Draft Proposal for Category C requirements

Consolidated document (including homework) after the 13th session

OICA-CLEPA homework in Blue **This document is based on ACSF-13-16**

1 Figure Minimum detection area

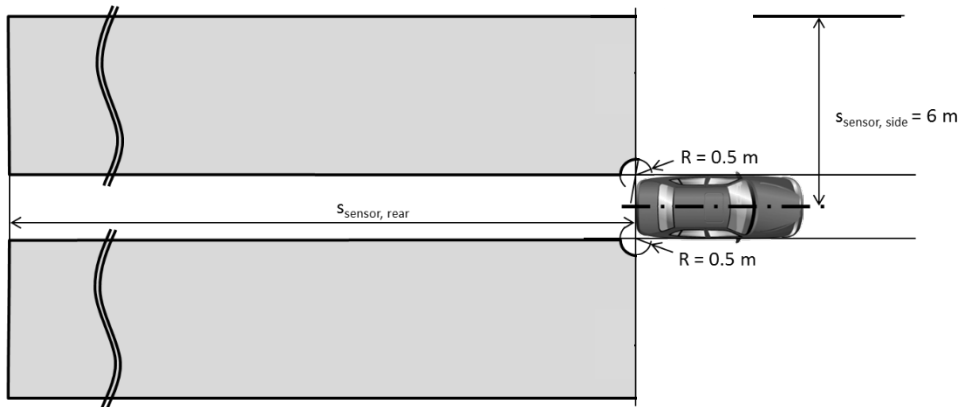
5.6.5.8.2. ~~The minimal detection range to the left and to the right (side) of the ACSF Category [C1] system shall be at least 6 m (see drawing) measured from the medium longitudinal centerline of the vehicle equipped with ACSF of Category [C1]~~

The vehicle system detection area on ground level shall be at minimum as shown in the figure below.
